# Access Compliance Report

## Public Rights-of-Way

Intersection ID: 30049	Main Street: SUMMER_COACH_DR	Cross Street: SUNSET_VILLAGE_DR	Location: E
ADA ID: 3C192A8C57A0	Ramp Type: Perp	Initial Pass/Fail: Fail	Overall Compliance: No
		Severity Score: 12.5

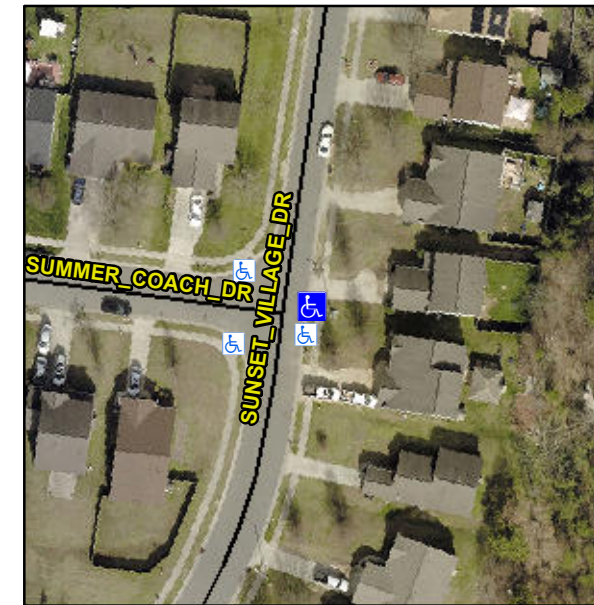
**Not Found, R304.5.3**

Compliance	Description	Data	Compliance	Description	Data
N/A	Ramp Length (in)	48.0	Yes	Ramp Slope (%)	6.4
Yes	Ramp Width (in)	48.0	No	Ramp XSlope (%)	5.3
N/A	Flare Type LT	N/A	N/A	Flare Type RT	N/A
N/A	Flare Slope LT (%)	N/A	N/A	Flare Slope RT (%)	N/A
N/A	Flare Traversable LT?	N/A	N/A	Flare Traversable RT?	N/A
N/A	Landing Length (in)	N/A	N/A	DWS Provided?	N/A
N/A	Landing Width (in)	N/A	N/A	DWS Contrast?	N/A
N/A	Landing Slope (%)	N/A	N/A	DWS Length (in)	N/A
N/A	Landing X Slope (%)	N/A	N/A	DWS Full Width?	N/A
N/A	Landing Curb? (Y/N)	N/A	N/A	DWS Offset (in)	N/A
N/A	Shared Landing?	N/A			
N/A	Gutter Ponding?	N/A	N/A	Gutter Slope (%)	N/A
N/A	Gutter Lip Ht (in)	N/A	N/A	Gutter X Slope (%)	N/A
N/A	Painted X Walk1?	No	N/A	Painted X Walk2?	N/A
	X Walk 1 Direction	To NW		X Walk 2 Direction	N/A
N/A	X Walk 1 Width (in)	N/A	N/A	X Walk 2 Width (in)	N/A
	X Walk 1 Slope (%)	2.7		X Walk 2 Slope (%)	N/A
	X Walk 1 X Slope (%)	7.9		X Walk 2 X Slope (%)	N/A

**Remove & Replace Entire Ramp.**
